AGENDA

ARCHITECTURAL REVIEW BOARD MEETING
CITY HALL, 385 SOUTH GOLIAD, ROCKWALL, TEXAS
AUGUST 30, 2022 IN THE CITY COUNCIL CONFERENCE ROOM AT 5:00 PM

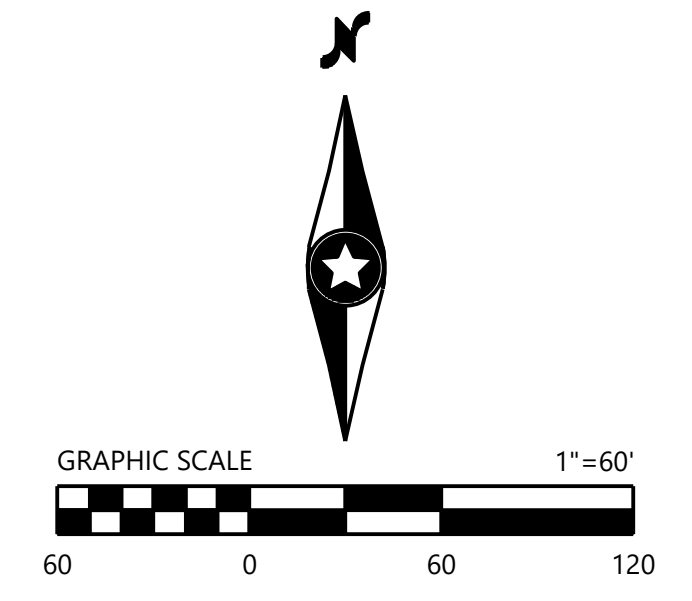
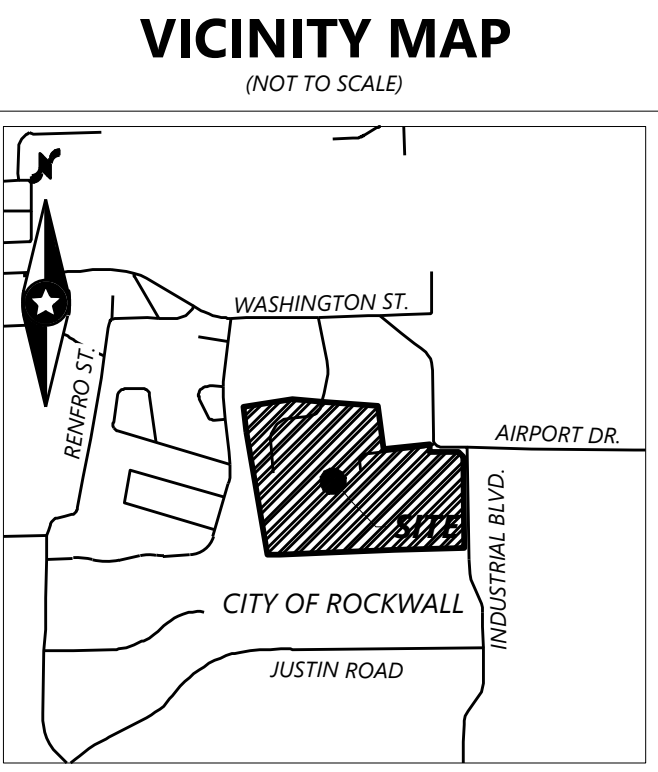
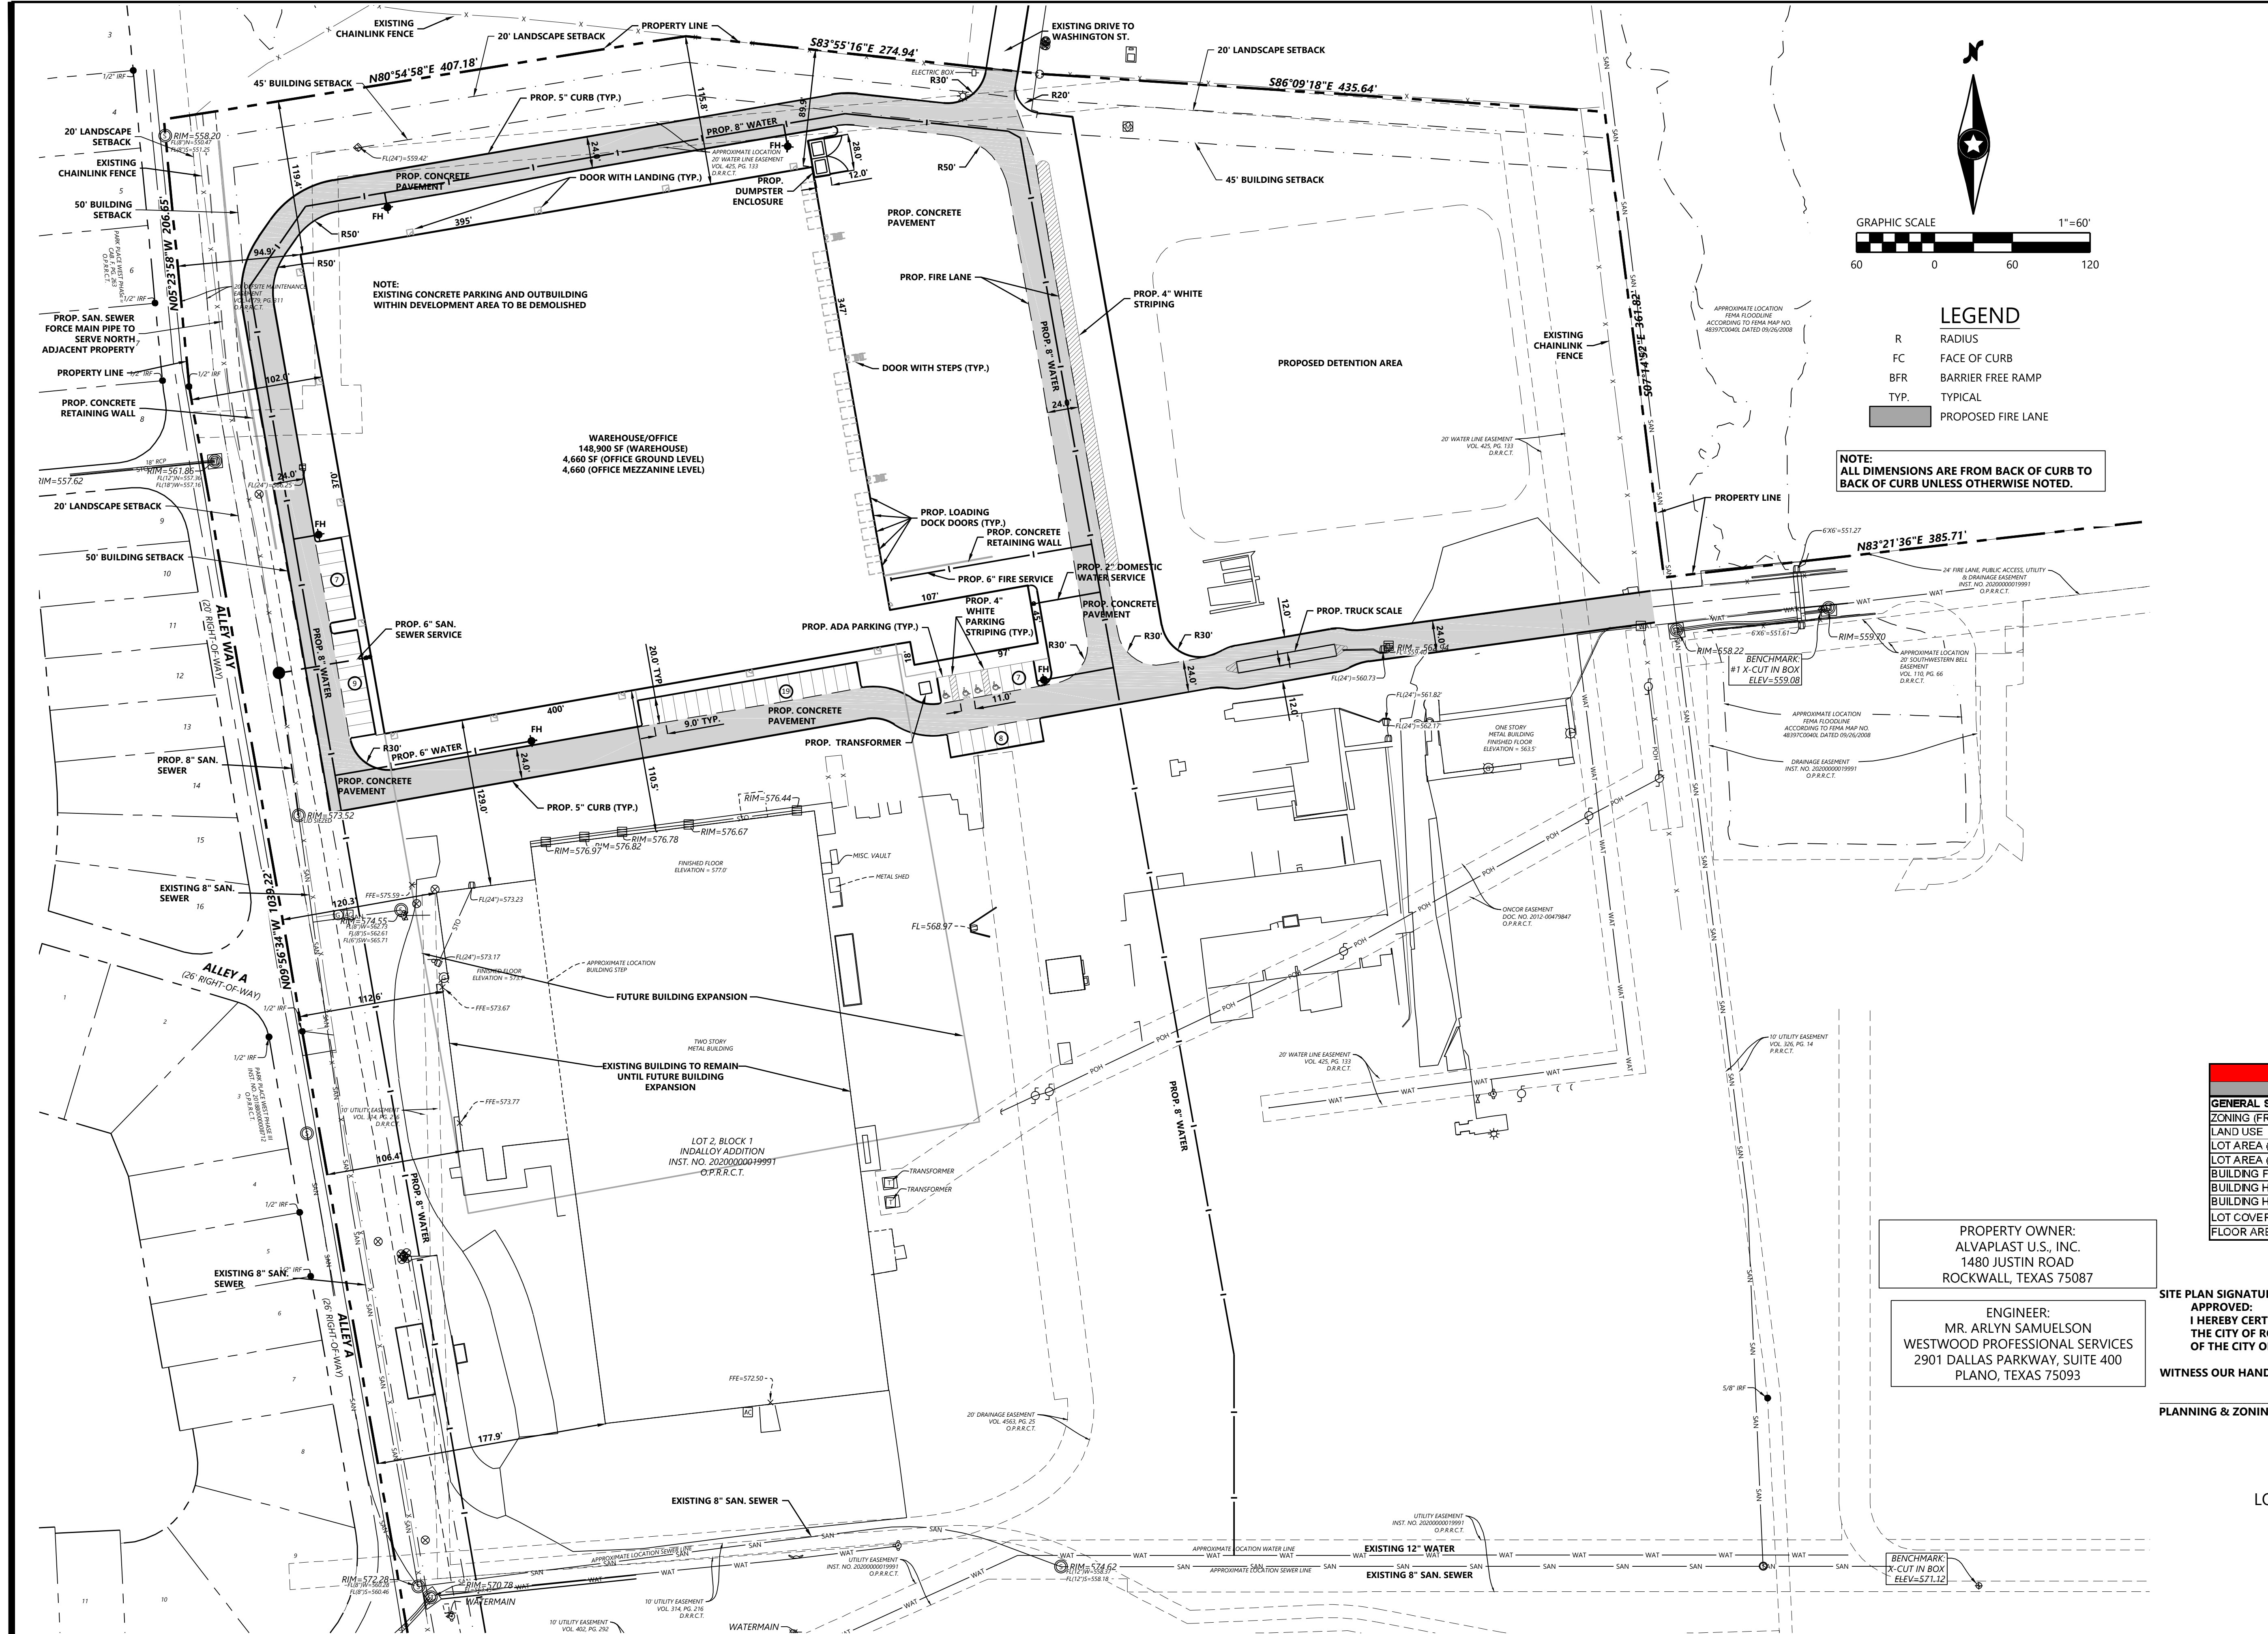
Pending review comments by City of Rockwall Planning and Zoning staff of our Site Plan Submittal Package submitted on 8/19/2022, variances may be requested at a later date, once we are made aware of which variances need to be requested, if any.
